# Exhibit A-50: McShane haul road geological report

Re: **Proposed Grip Mine Haul Road**  
Comments Regarding Potential Geology Hazards

Figure 1. Lidar bare earth imagery of proposed access road and Swede Creek valley (2017 lidar via the Washington State Department of Natural Resources Lidar Portal). Note the lidar imagery predates the recent widening work on the proposed haul road.

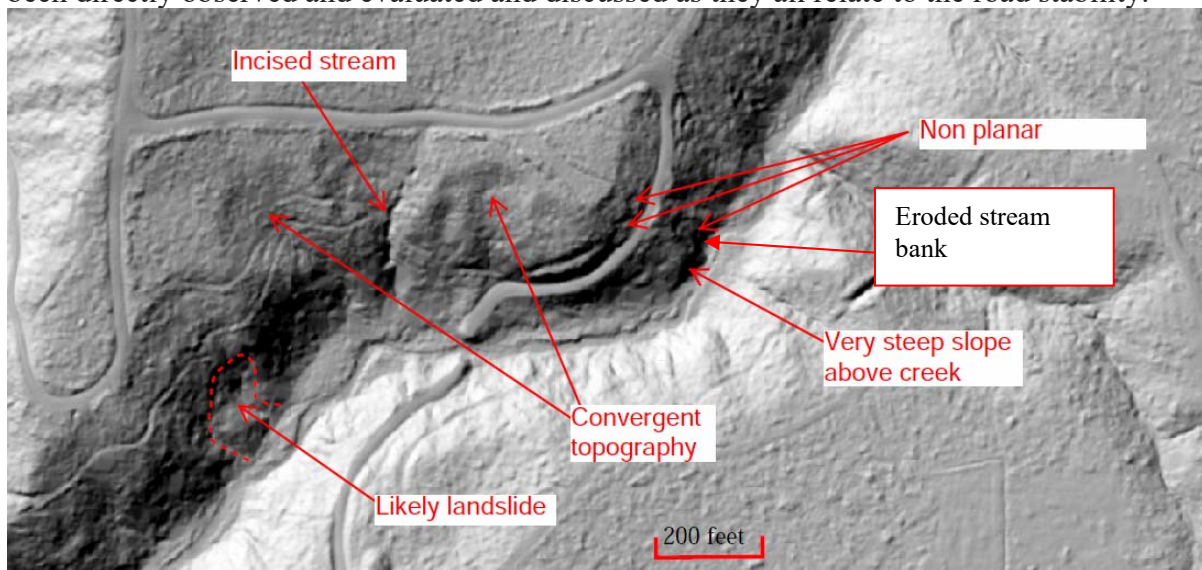
Lidar bare earth imagery is a remarkable tool for identifying landforms prior to visiting a site. My own review of the lidar identified numerous non planar features (Figure 1) that should have been directly observed and evaluated and discussed as they all relate to the road stability.

The features indicated in Figure are all non planar features that were not recognized, discussed or analyzed in the AES report. These features are all potential landslide or erosion hazard areas that should be evaluated in more detail.

AES provides one paragraph regarding their visual slope reconnaissance. None of the features that are shown on the Figure 1 lidar are discussed or assessed. Each of the features indicated in Figure 1 and their relevance to the assessing the slope area of the proposed haul road are discussed below.

Swede Creek and stream processes along Swede Creek are never discussed. This is a significant omission in that the slopes in question are the result of Swede Creek having eroded a deep narrow steep sided valley. Lidar imagery clearly shows an active stream channel and active stream movement and evidence of recent erosion. There is a likely landslide associated with the creek a short distance down stream and what appears to be a steep stream cut slope below the proposed haul road (indicated on Figure 1) that is not mentioned or discussed. The lidar imagery shows what appears to be slope slump (a non planar feature) just above the steep stream cut slope. Further erosion at this location will undermine the slope the proposed haul road crosses. Stream erosion of the slope below the haul road is never mentioned or discussed in the report.

The convergent topography below the east-west section of the road above the slope was not addressed. These slopes are clearly not planar. What are these features? What geomorphic processes formed these features and how active are those processes? Could the road above impact the processes? Do the processes on these slopes pose a long term risk to the road?

The incised stream channel below the east-west road above the slope is never mentioned or discussed. The lidar image clearly shows this stream is a sharp feature suggesting recent active erosion. Does the road impact water flow to this feature? Does increased erosion from road drainage potentially impact the public resources down slope in Swede Creek?

No mention of changes to road drainage are made regarding the incised stream below the east-west section of the road (Figure1) as this incised stream was never observed or discussed in the report.
